**RFB NO. 313083 - ADDENDUM NO. 1**

**CONSTRUCTION OF EAST HIGHWAY GARAGE – SALT  
STORAGE FACILITY (BID PACKAGE A) AND  
MEDICAL EXAMINER OFFICE BUILDING (BID PACKAGE B)**

**DEPARTMENT OF PUBLIC WORKS,  
HIGHWAY & TRANSPORTATION  
3562 COUNTY HIGHWAY AB  
MCFARLAND, WISCONSIN**

**3 Salt Building - Framing - Phase 1**  
1/16" = 1'-0"

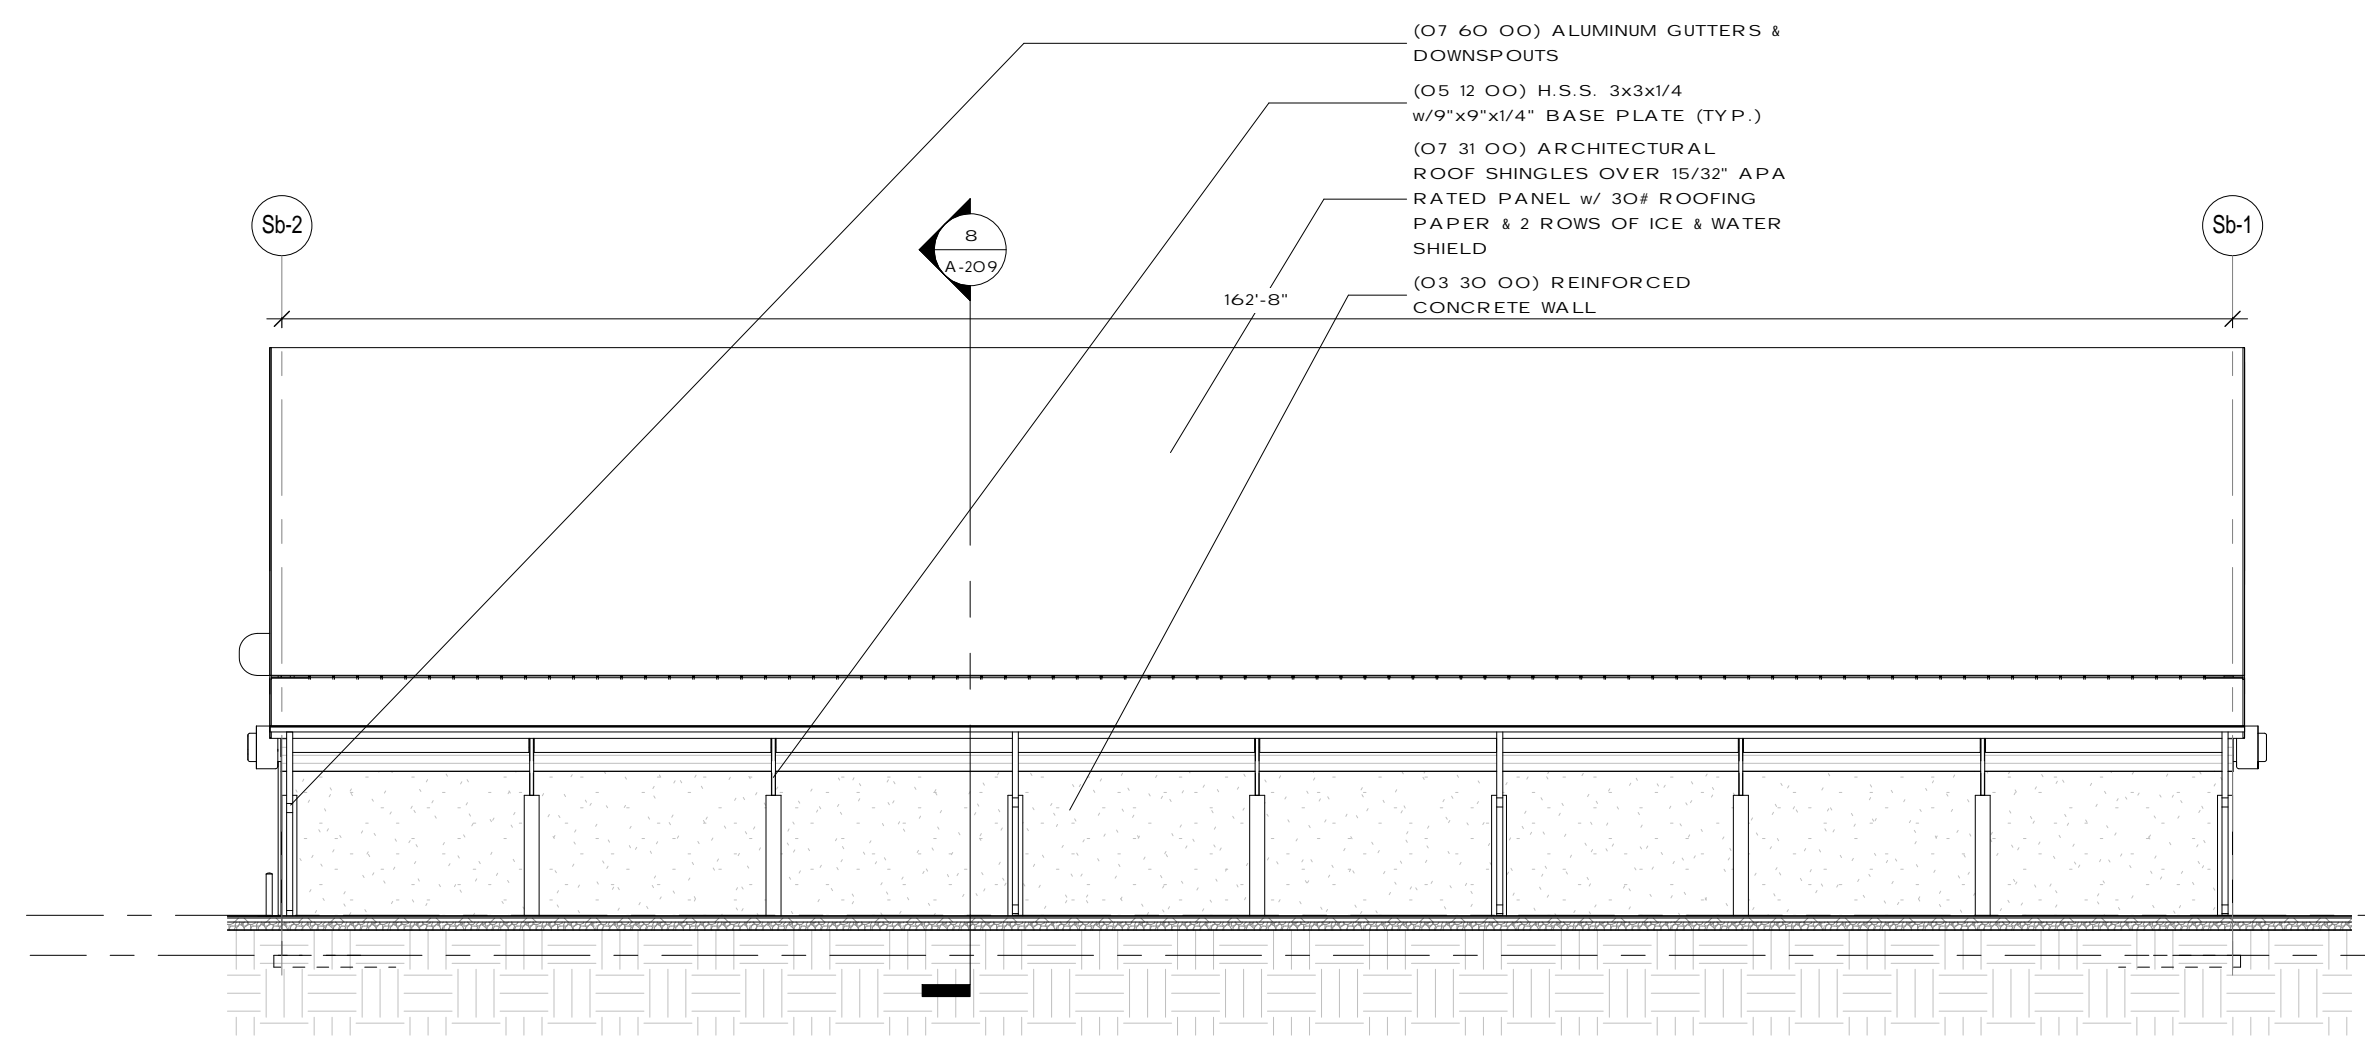
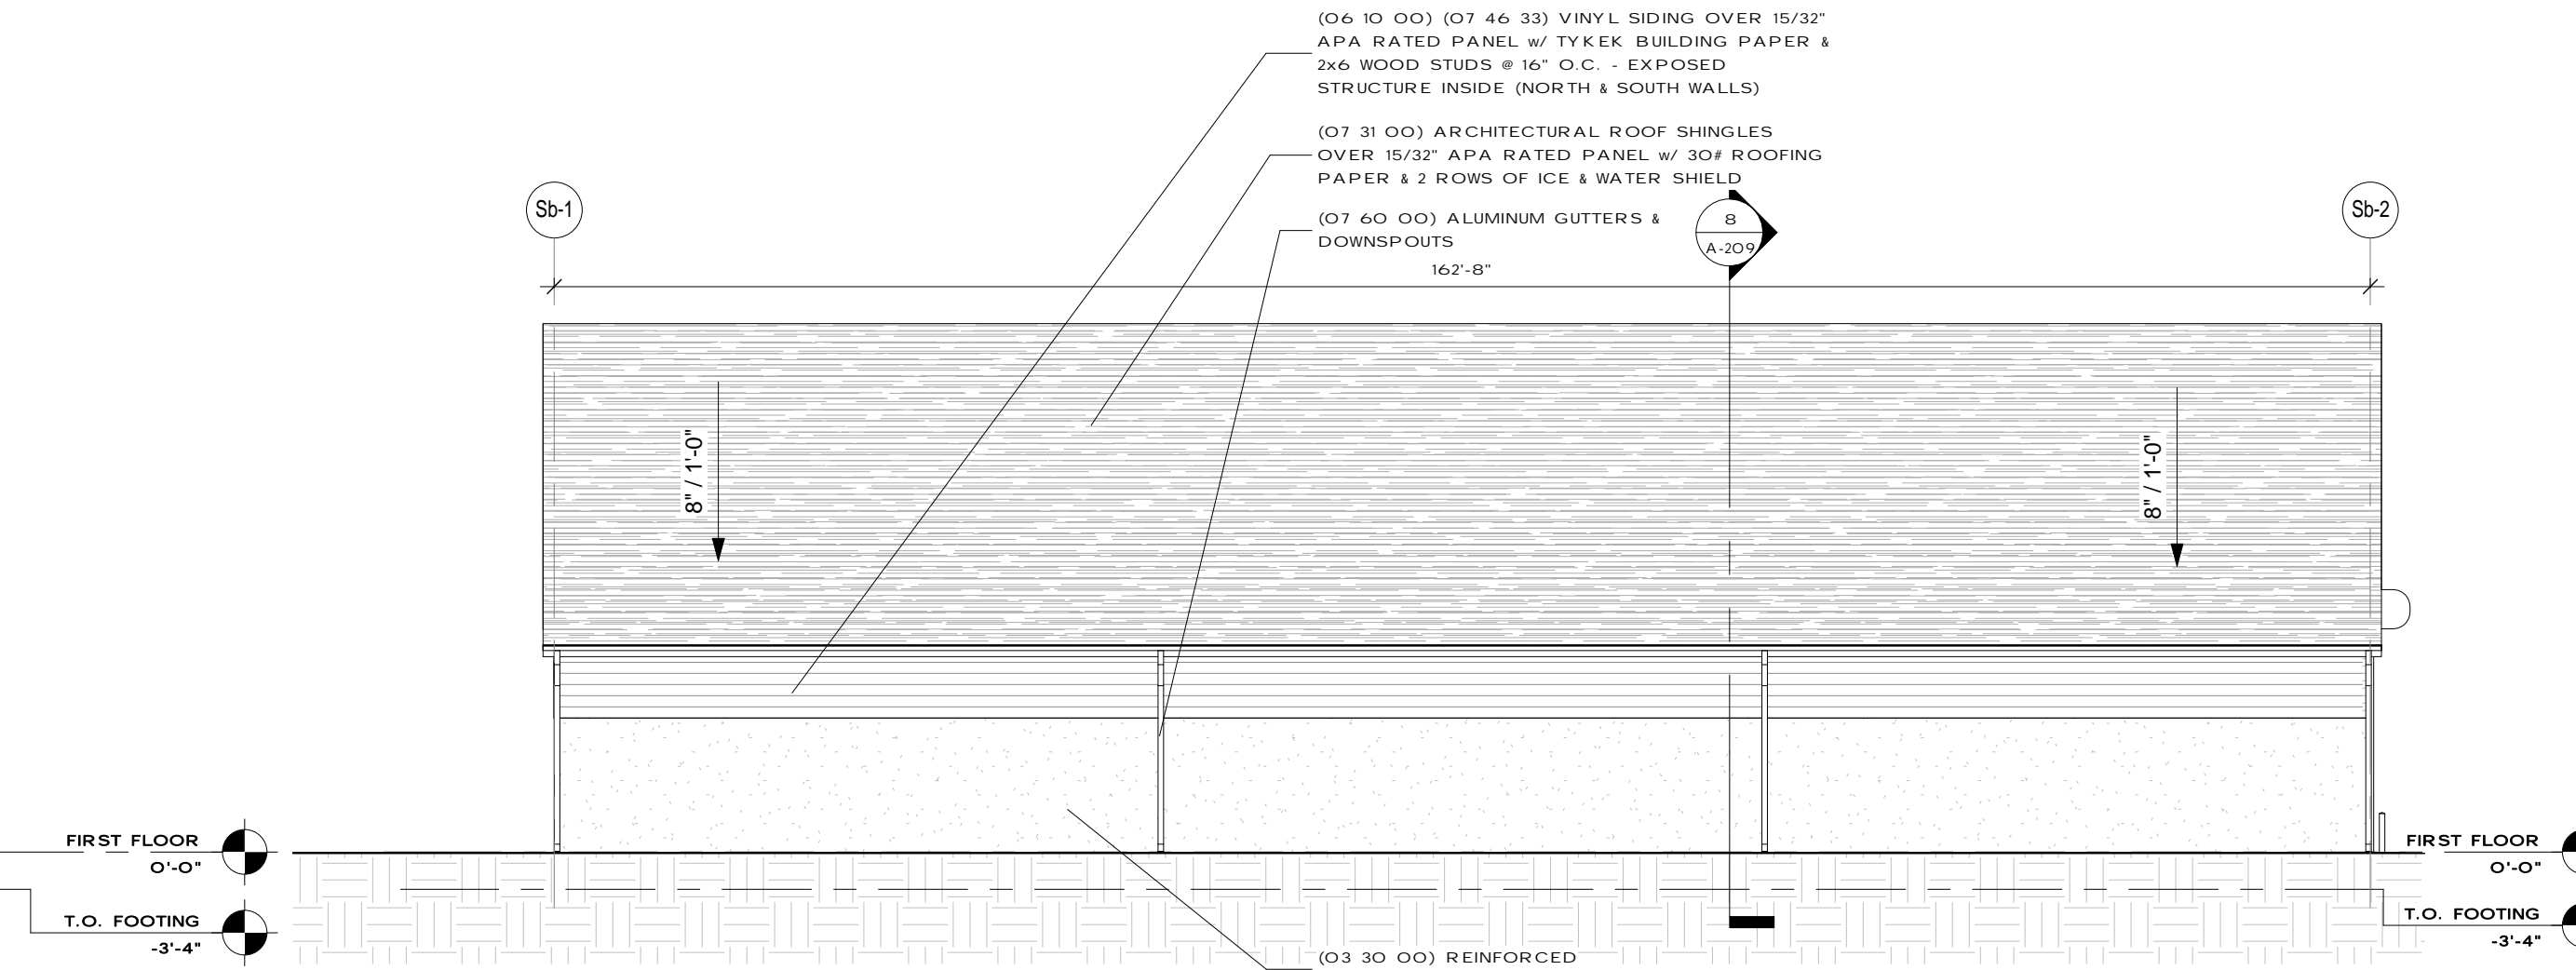
1. See revised sheet showing door tags.

1 WALL SECTION DETAIL  
1 1/2" = 1'-0"

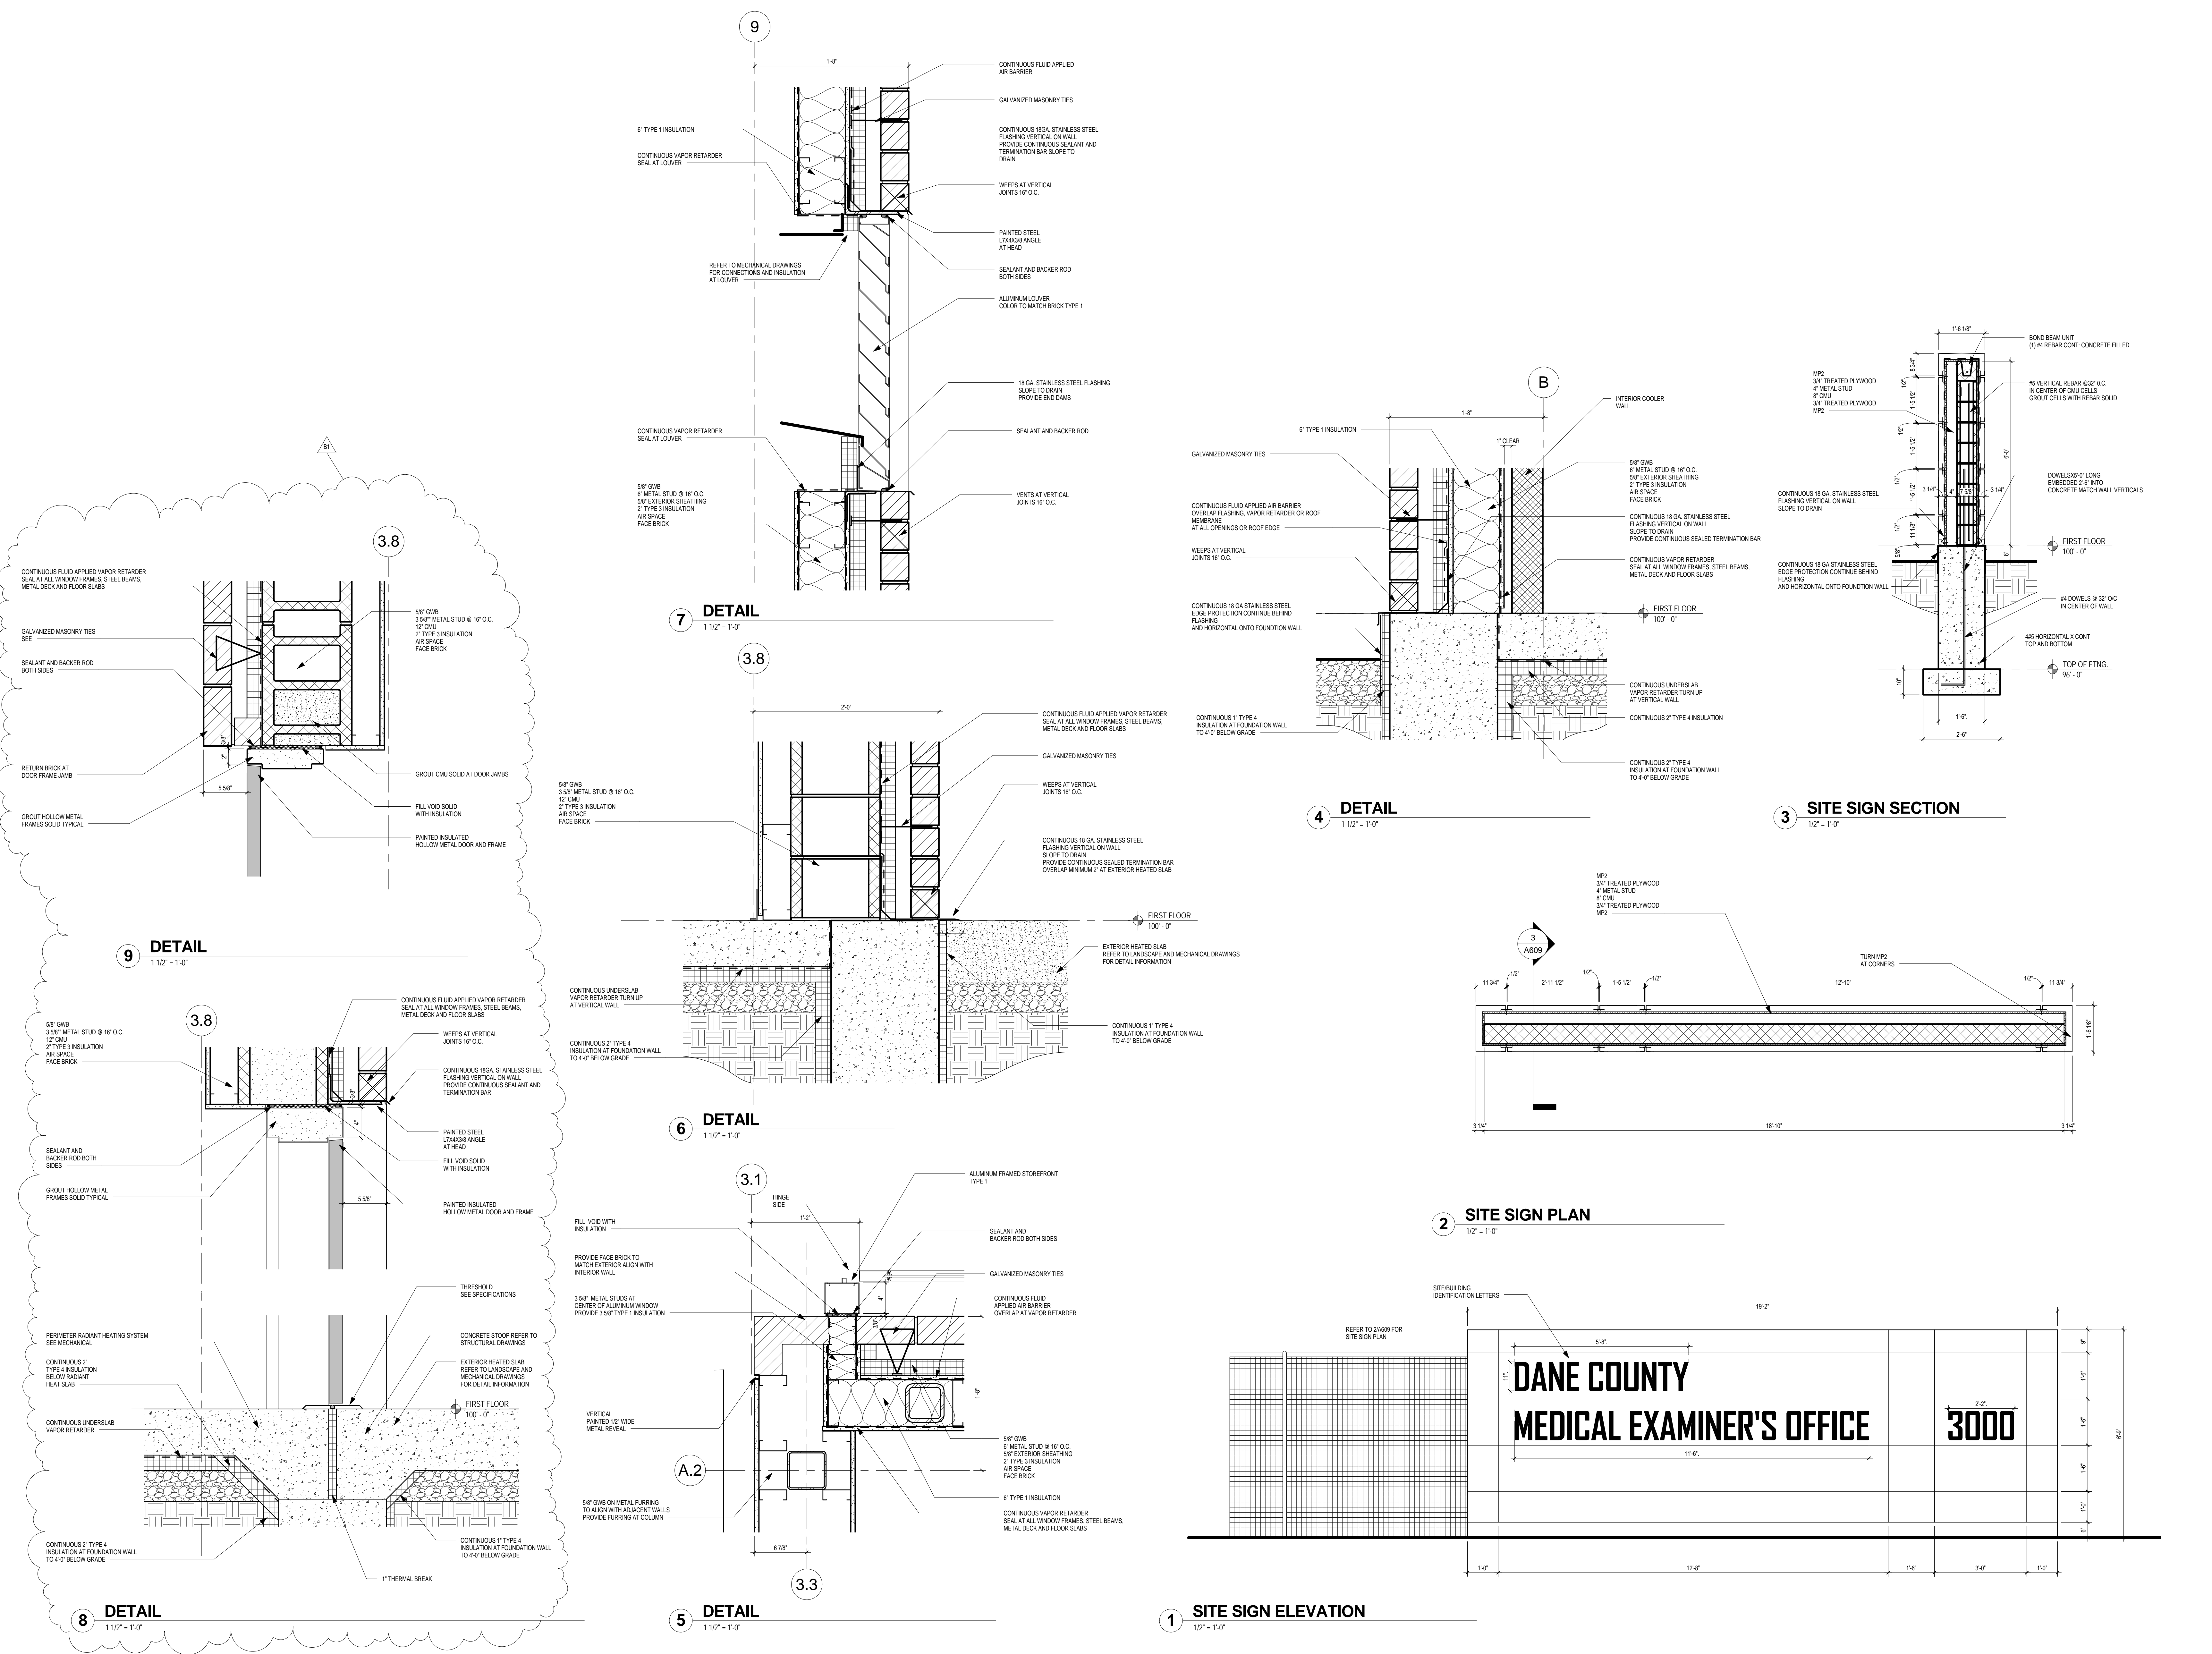
40. SHEET A503:
  - a. Replace in its entirety.
  - b. 1, 2 and 3/A503: Revised wall sections for clarification of Pre-Engineered Metal Building responsibilities.
